## ASSESSMENT REPORT

### Block 11 - Central Park, Chippendale SSD 6376 MOD 5

**Figure 4** – The proposed Level 13 layout with the current location of plant equipment shown by the blue clouded line (source: Applicant's EIS)

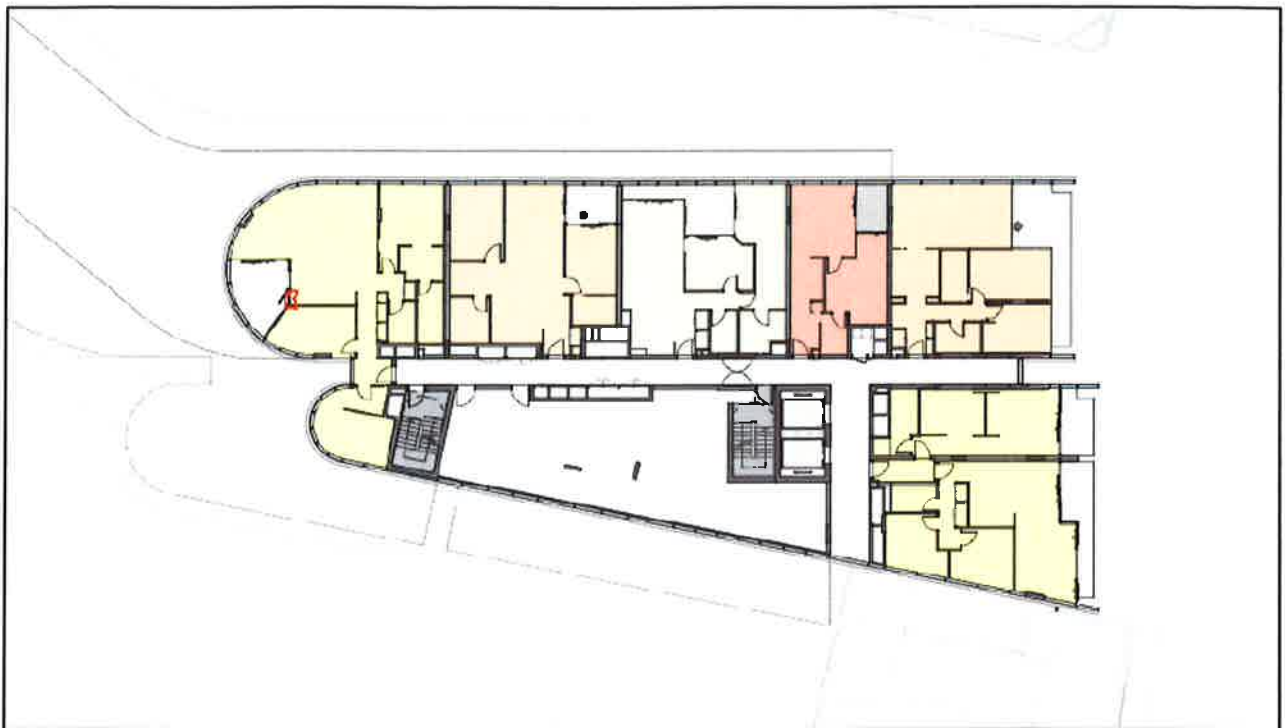
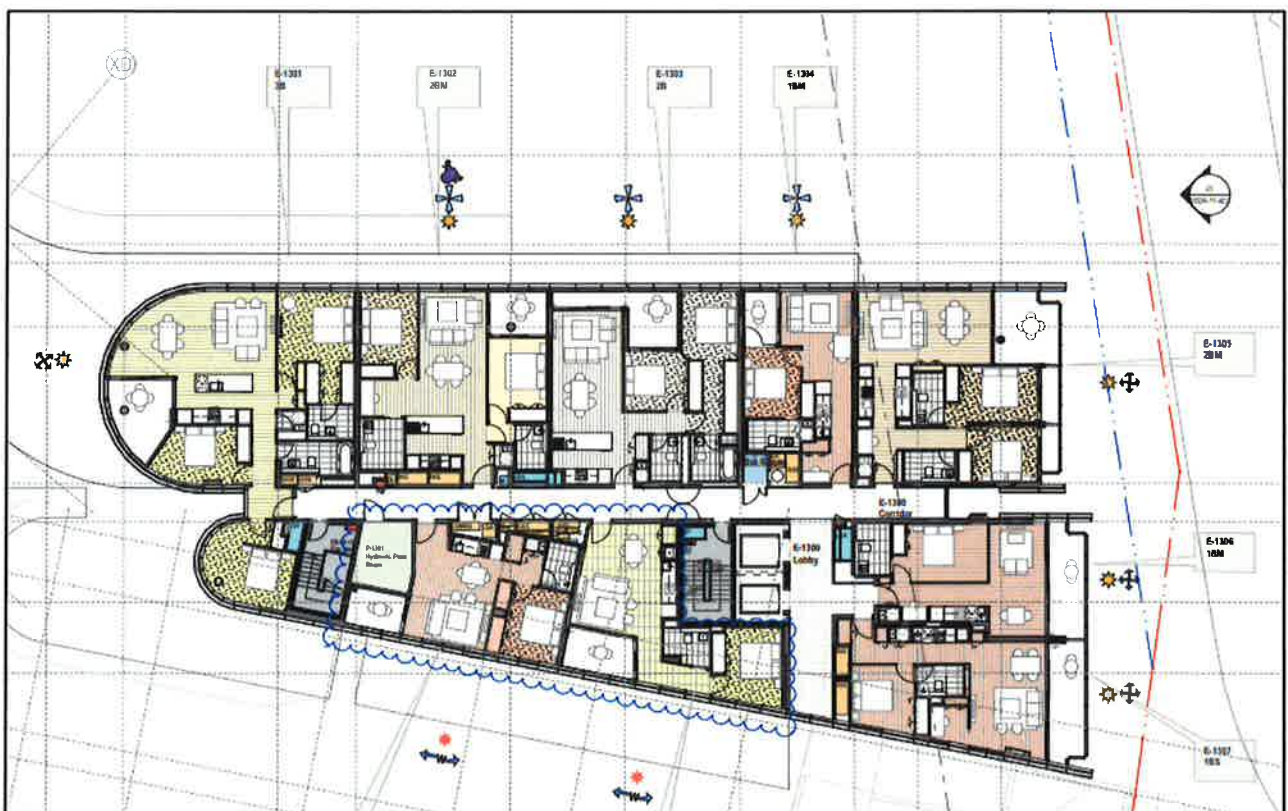
- remove Level 13 plant room services and replace with 2 x one-bedroom units (see **Figures 3 and 4**)
- modify eight units on the northern elevation by replacing loggias with balconies (see **Figures 5 and 6**)
- include additional projecting wall signage above the ground level entry to retail tenancies
- remove internal stairs (stair 5) between Ground Level and Level 1
- make minor internal and external modifications to service and plant structures
- reduce the overall GFA of the building from 25,220 sqm to 25,194 sqm as a result of additional area used for services.

| <i>Issue</i>                                                             | <i>Consideration</i>                                                                                                                                                                                                                                                                                                                                                                                                                                                                                                                                                                                                                                                                                                                                                                                                                                                                                                                                                                                                                                                                                                                                                                                                                                                                                                                       | <i>Recommendation</i>                          |
|--------------------------------------------------------------------------|--------------------------------------------------------------------------------------------------------------------------------------------------------------------------------------------------------------------------------------------------------------------------------------------------------------------------------------------------------------------------------------------------------------------------------------------------------------------------------------------------------------------------------------------------------------------------------------------------------------------------------------------------------------------------------------------------------------------------------------------------------------------------------------------------------------------------------------------------------------------------------------------------------------------------------------------------------------------------------------------------------------------------------------------------------------------------------------------------------------------------------------------------------------------------------------------------------------------------------------------------------------------------------------------------------------------------------------------|------------------------------------------------|
|                                                                          | <ul style="list-style-type: none"> <li>The Applicant notes that a significant portion of the approved plant area on Level 13 was originally intended to accommodate heat rejection equipment for the retail, childcare and community spaces. Most of this area however, is no longer needed because it will be connected to the precinct's central thermal plant which will enable more efficient heating and cooling of the building.</li> <li>The Department considers the proposed modification to Level 13 is acceptable as it would not change the height, bulk or scale of the approved building and it would not result in any adverse environmental impacts on adjoining neighbours. Further, the connection of the building to the precinct's central thermal plant will enable more efficient heating and cooling of the building, improving its sustainability.</li> </ul>                                                                                                                                                                                                                                                                                                                                                                                                                                                      | amendments necessary.                          |
